DOCKETED	
Docket Number:	24-OPT-04
Project Title:	Potentia-Viridi Battery Energy Storage System
TN #:	262577
Document Title:	Revised Section 3-4, Geological Hazards and Resources in Track Changes Format
Description:	This document includes the tracked changes version of revised Section 3.4, Geological Hazards and Resources which addresses the CEC's request for additional clarification.
Filer:	Ronelle Candia
Organization:	Dudek
Submitter Role:	Applicant Consultant
Submission Date:	4/2/2025 8:34:33 PM
Docketed Date:	4/3/2025

3.4 Geological Hazards and Resources

FIGURE 3.4-1

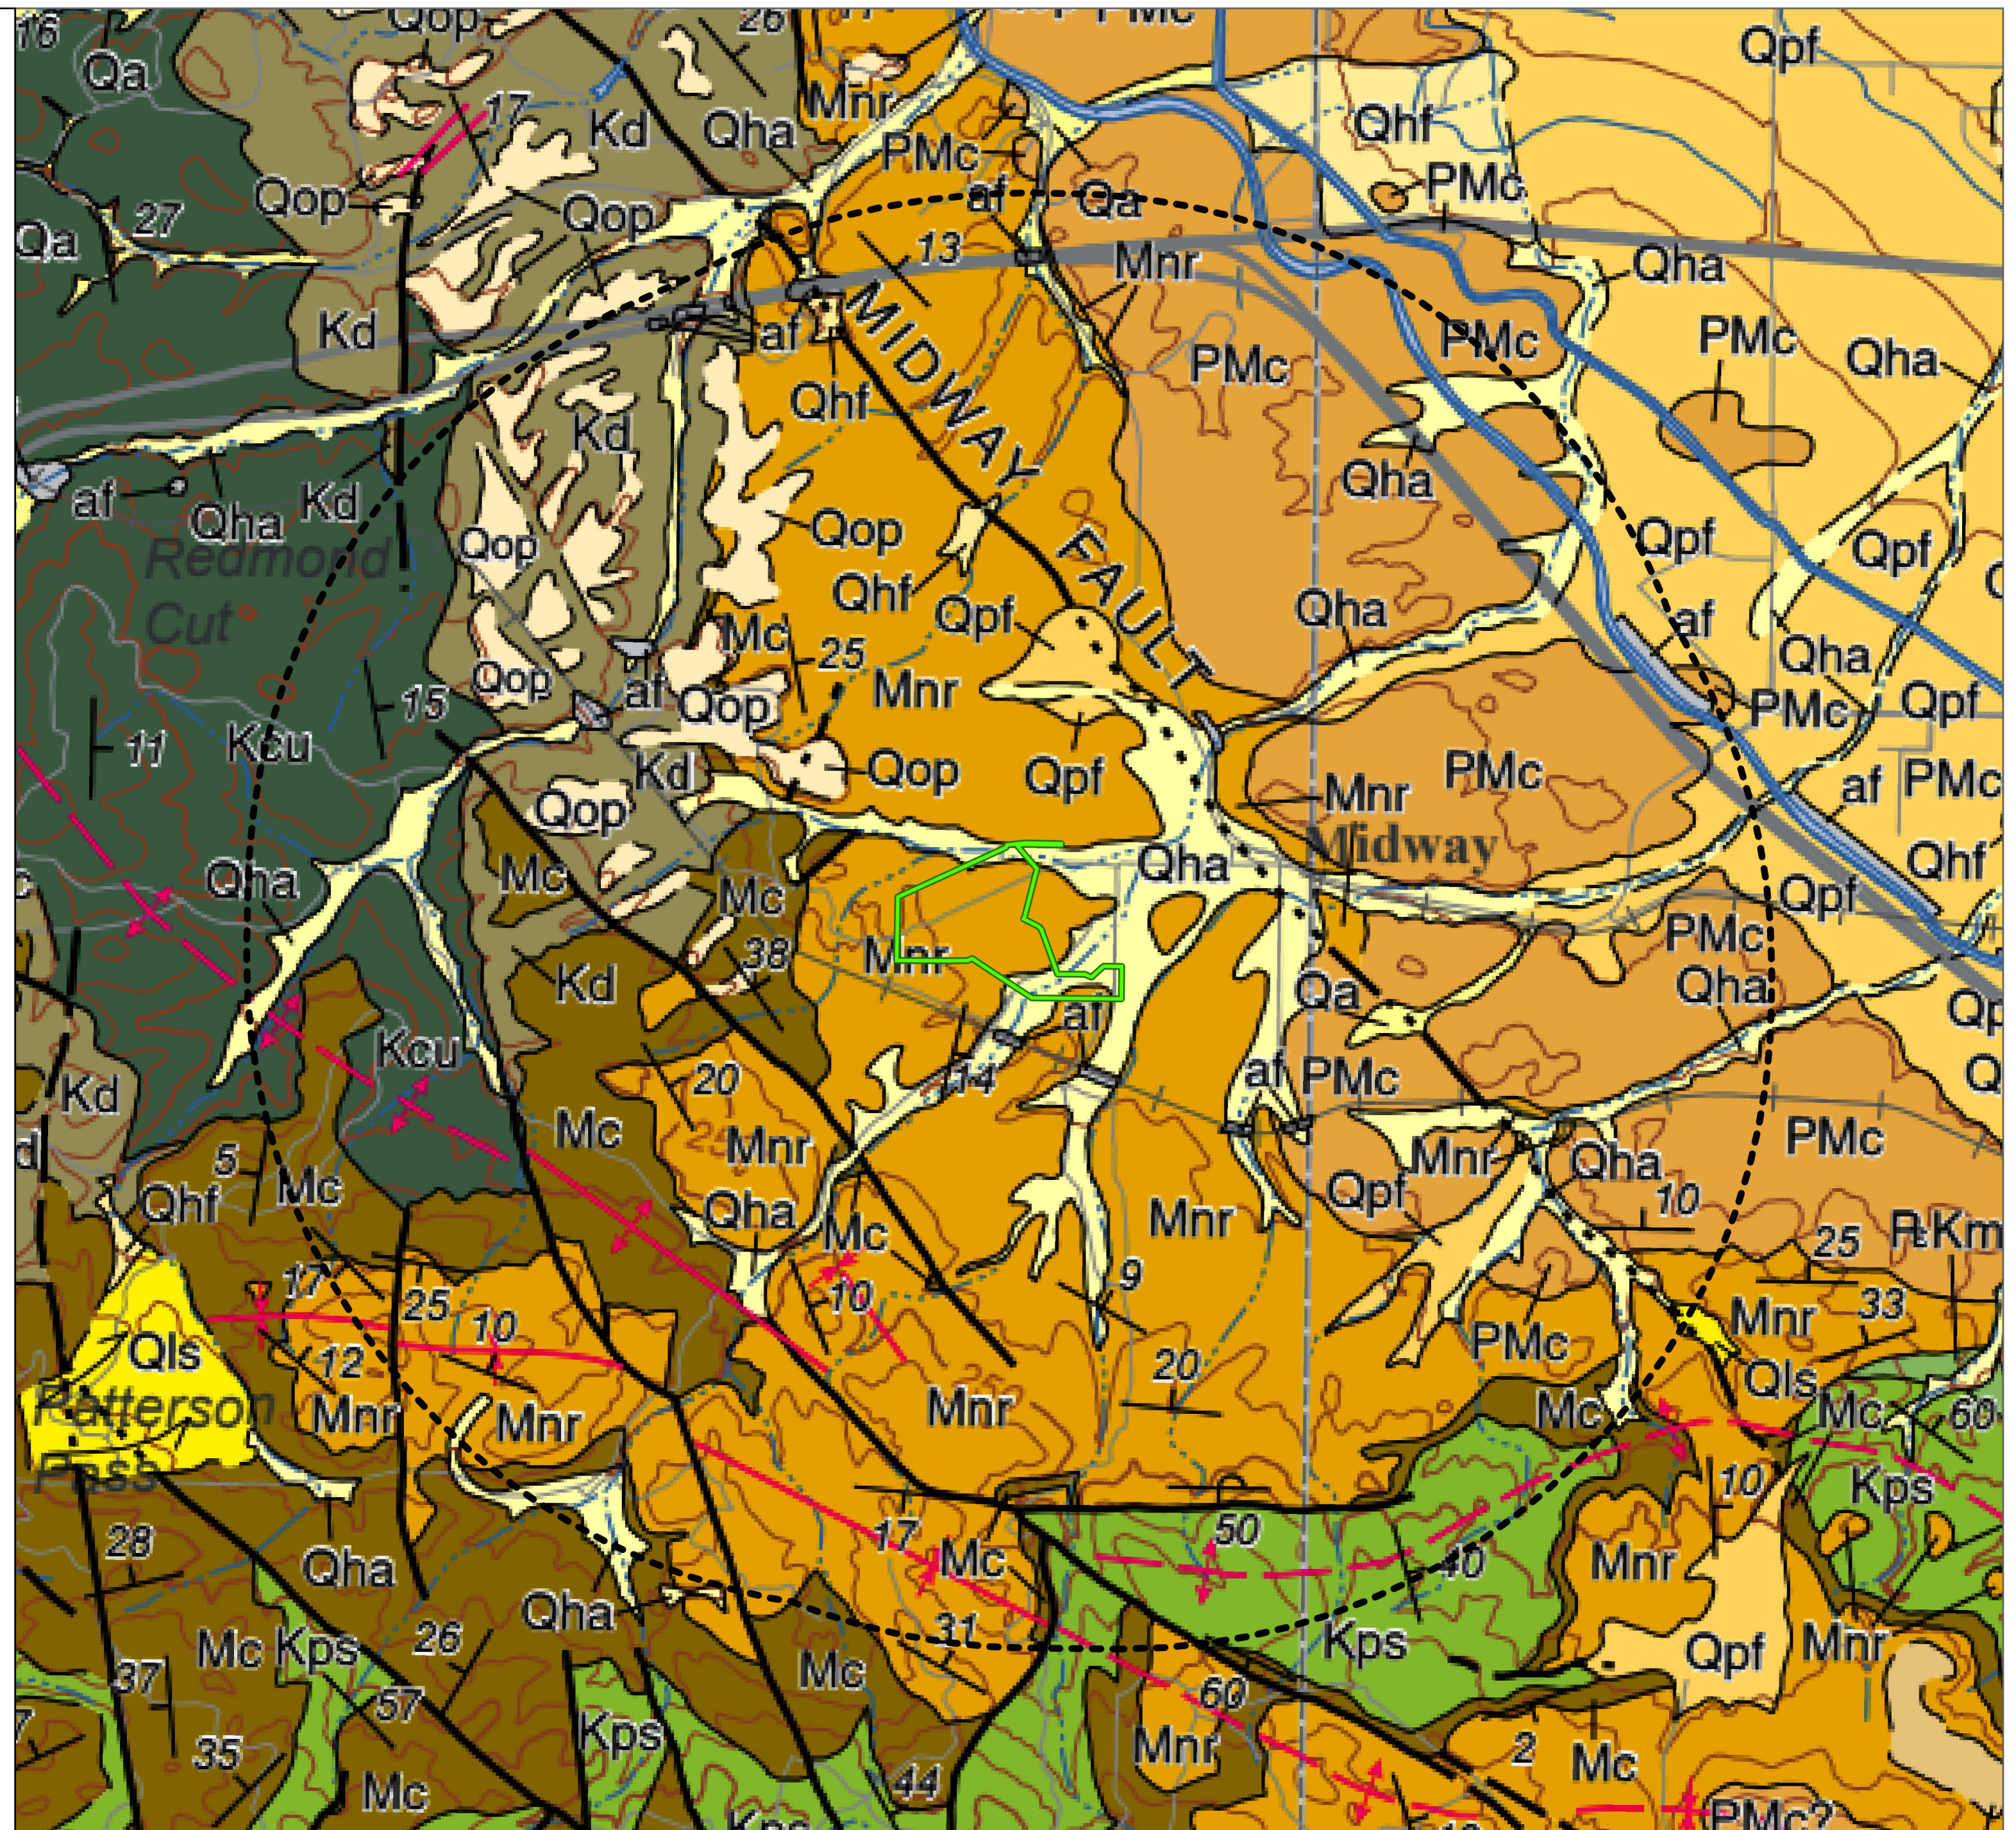
The Project site encompasses flat to rolling topography, located adjacent to a northeast trending seasonal drainage. The subsurface of the Project site is made up of Holocene alluvium and Miocene Neroly Formation (Figure 3.4-1, Surface Geology). [The following is a summary of geologic units underlying the Project site.](#)

The following is a summary of geologic units within 2.0 miles of the Project site, from youngest to oldest (Figure 3.4-1).

Deleted: Holocene alluvium typically consists of unconsolidated to semi-consolidated sand, silt, clay, and gravel....
